S.L. Number:	ZE-2009-05																				
Date of issue:	November 24, 2009																				
Subject:	Aileron Bell-Crank stiffeners for the CH 601 XL/CH 650E.																				
Affected Models:	All CH 601XL/CH 650E models built and operated as ULM (MTOM of 450 kg + 5%) as defined by LTF-UL standards (or similar).																				
Serial Number(s)	All affected models																				
Manufactured by:	Czech Aircraft Works (CZAW) and others.																				
Purpose:	According to the <u>Institute for Reliability Engineering</u> at the <i>Technical University of Hamburg, Germany</i> , this modification has the potential to further reduce the possibility of non-linear vibrations in the aileron control system of the affected aircraft.																				
Directed Action(s):	<p>This upgrade includes one (1) extra channel per wing to support the aileron bell-crank attachment and additional “L” angles on the top and bottom wing skins as illustrated on the drawings (6Z-1G). See references for exact materials, dimensions, locations and installation details.</p> <p>Parts include:</p>

ULM Aileron Bell-crank Changes

6Z-1G

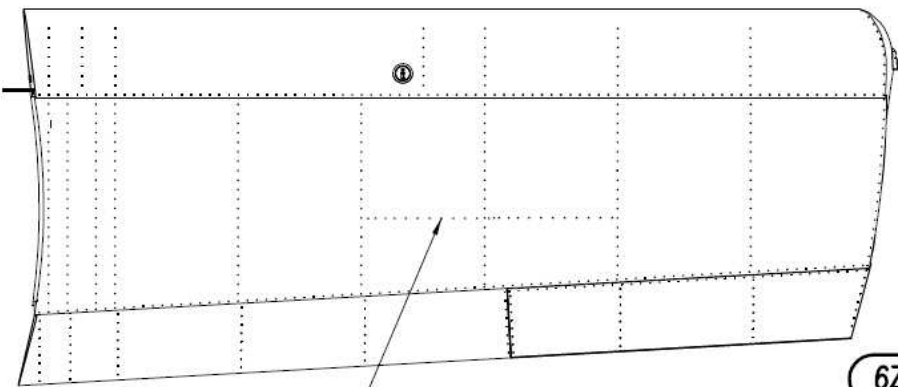
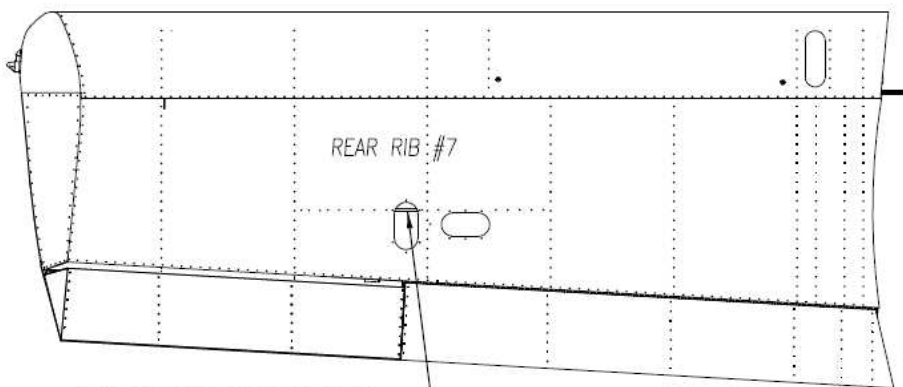
6Z-1G-1
REPLACES 6W6-10 BY 6Z-1G-1
ADD 2 RIVETS A5 IN ENDS
OF 6Z-1G-2 ANGLES

6Z-1G-2 ANGLE IN LINE WITH
FRONT FLANGE OF BELLCRANK
SUPPORT CHANNEL 6Z-1G-1
TOP AND BOTTOM

6Z-1G-2 ANGLES
OUTBOARD OF RR #7
TOP AND BOTTOM
A4 PITCH 50

6Z-1G-1 BELLCRANK SUPPORT CHANNEL
t=.040" 6061-T6 (2 REQ'D)

6Z-1G-2 ANGLES
A4 PITCH 40

6Z-1G-2 STANDARD L ANGLE
t=.025" 6061-T6 (4 REQ'D)
TRIM TO FIT

BOTTOM SIDE OF RIGHT WING

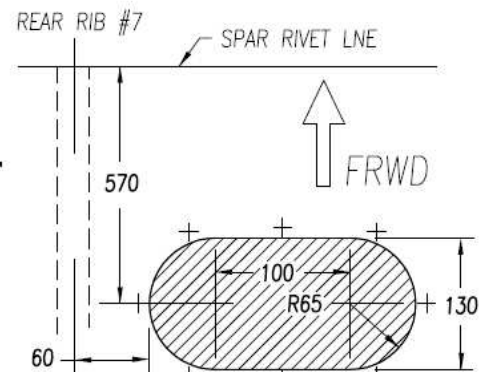
AILERON ACCESS COVER IS
REPLACED TO OVERLAP ON
OUTSIDE WITH NUTPLATES
OR RIV-NUTS ON BOTTOM SKIN

CUTOUT IN BOTTOM SKIN 6W8-2
TO REPLACE CHANNEL WITH 6Z-1G-1
AND TO ADD STANDARD L ANGLES.
Actual position of cut-out may vary.
Cut opening so that it will not interfere
with reinforcement angle to be installed

6Z-1G-3 AILERON ACCESS COVER
t=.025" 6061-T6 (4 REQ'D)
OVERLAPS ON OUTSIDE

NOTE: HOLE NOT REQUIRED IF REAR TOP SKIN
IS REMOVED TO DO MODIFICATION.
